RESPONSE TO REQUEST FOR ADDITIONAL INFORMATION

APR1400 Design Certification

Docket No. 52-046

RAI No.: 175-8034
SRP Section: 05.04.12 – Reactor Coolant System High Point Vents
Application Section: 5.4.12
Date of RAI Issue: 08/28/2015

Figure 5.4.12-1 Reactor Coolant Gas Vent System Flow Diagram

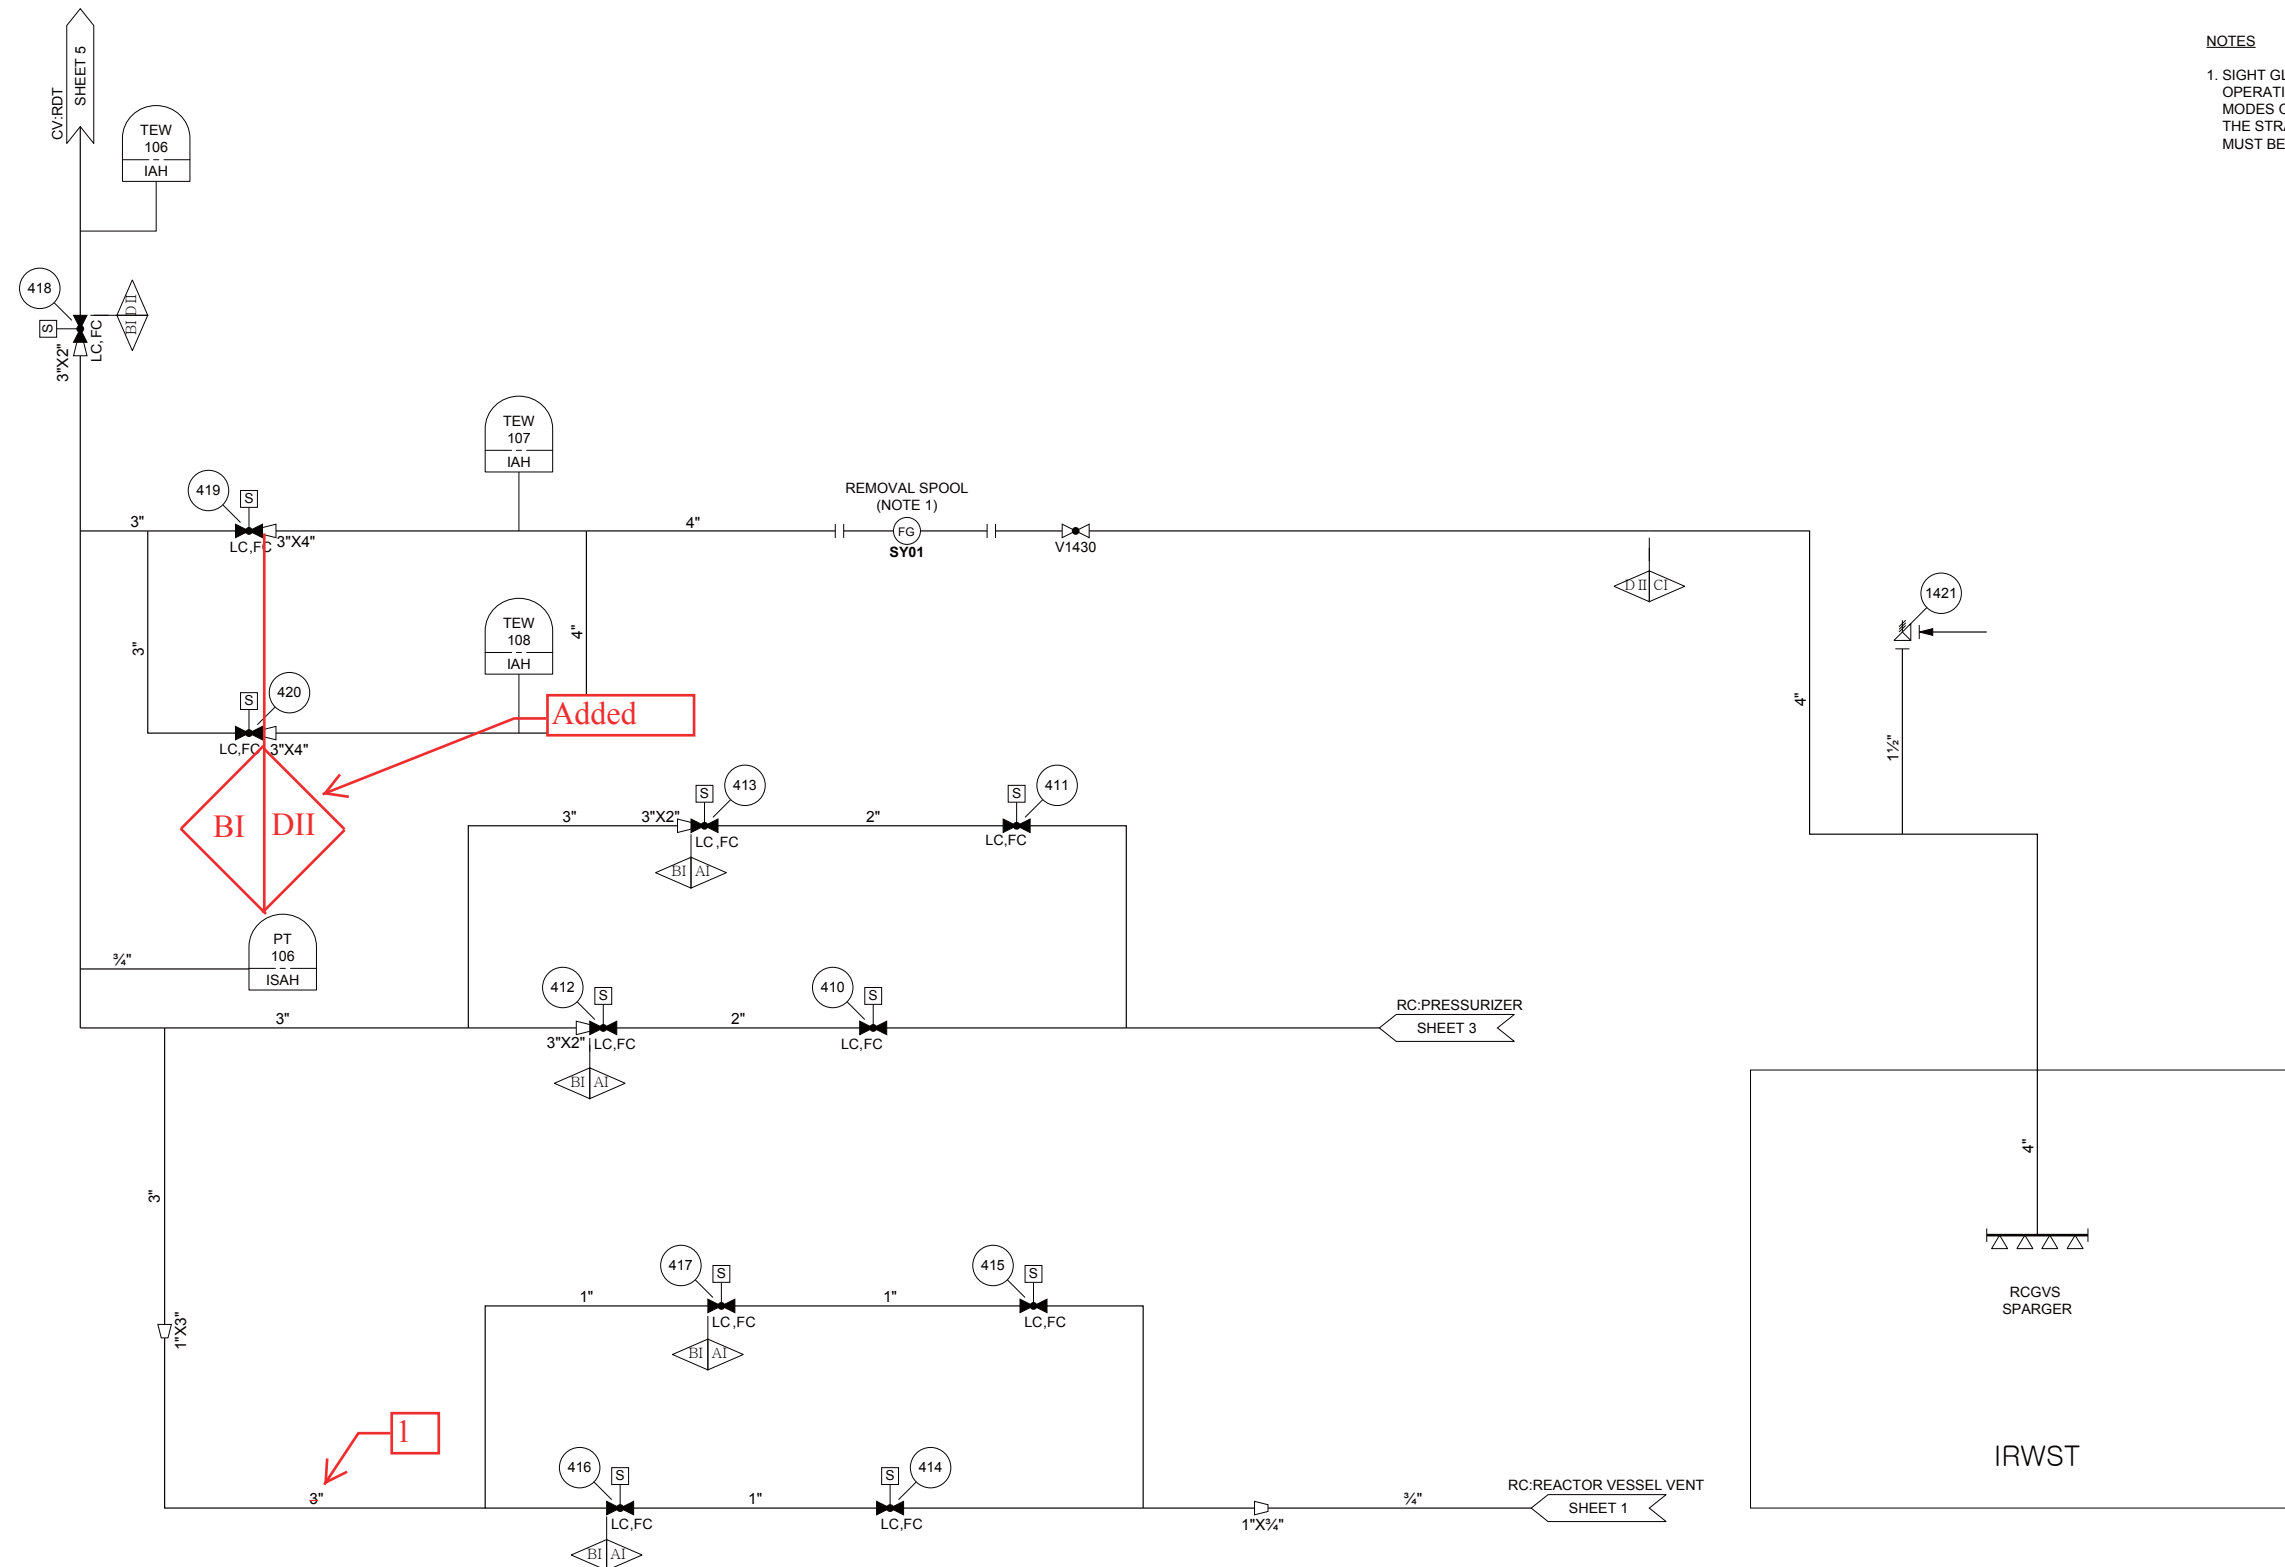
Staff identified an omission in DCD Tier 2, Figure 5.4.12-1, as well as a typographical error:

- (1) Markings that should indicate a transition from Seismic Category I and Quality Group B to Seismic Category II and Quality Group D after isolation valves V419 and V420 are missing.
- (2) The size of the line downstream of isolation valves V416 and V417 in the RCVH portion of the RCGVS appears to jump from 1" to 3" without passing through a flow enlarger.

The downstream line size of isolation valves V416 and V417 will be changed from 3 inches to 1 inch, and Qualify Group and Seismic Category will be added after V419 and V420 in DCD Tier 2, Figure 5.4.12-1 as shown in Attachment 2.

Figure 2.4.5-1 Reactor Coolant Gas Vent System

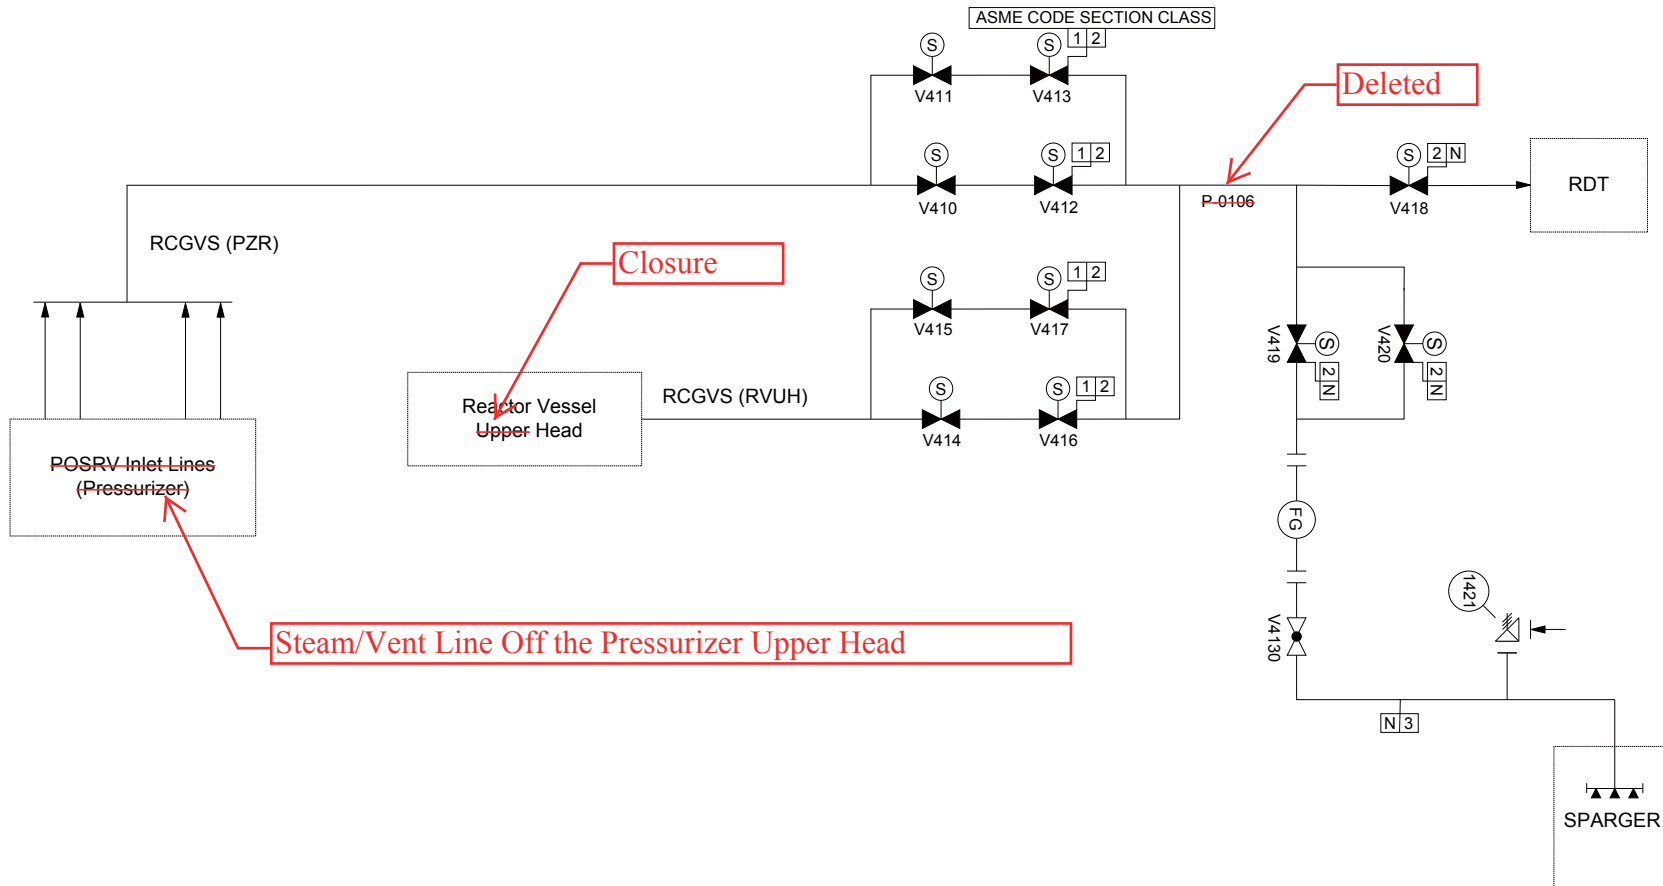
- a. Tier 1 refers to the "reactor vessel closure head" in the design description, consistent with Tier 2, Section 5.4.12, but refers to the "reactor vessel upper head" in Tables 2.4.5-1 and 2 and Figure 2.4.5-1.
- b. Tier 1, Figure 2.4.5-1 shows the inlet to the pressurizer portion of the RCGVS coming from the "POSRV Inlet Lines," whereas Tier 2, Section 5.4.12 says the inlet is at the "steam sample/vent line off the pressurizer upper head."
- c. A label for the RCGVS pressure instrument downstream of the parallel RCGVS flow paths is visible in Tier 1, Figure 2.4.5-1, but the actual instrument is not shown in the figure, nor are any of the other RCGVS instruments listed in Tier 1, Table 2.4.5-3.

Please update DCD Tier 1, Section 2.4.5 and/or DCD Tier 2, Section 5.4.12 to ensure consistency of terminology. In addition, for clarity in DCD Tier 1, Figure 2.4.5-1, either (1) properly indicate the RCGVS instrumentation or (2) remove the text label for the pressure instrument.

The terms “reactor vessel upper head” in Table 2.4.5-1, Table 2.4.5-2, and Figure 2.4.5-1 in DCD Tier 1 and Subsection 5.4.12.2.3 in DCD Tier 2, and “POSRV Inlet Lines” in Figure 2.4.5-1 in DCD Tier 2 will be changed to “reactor vessel closure head” and “Steam/Vent Line Off the Pressurizer Upper Head”, respectively. Also, the text label for the pressure instrument in Figure 2.4.5-1 in DCD Tier 1 will be deleted.
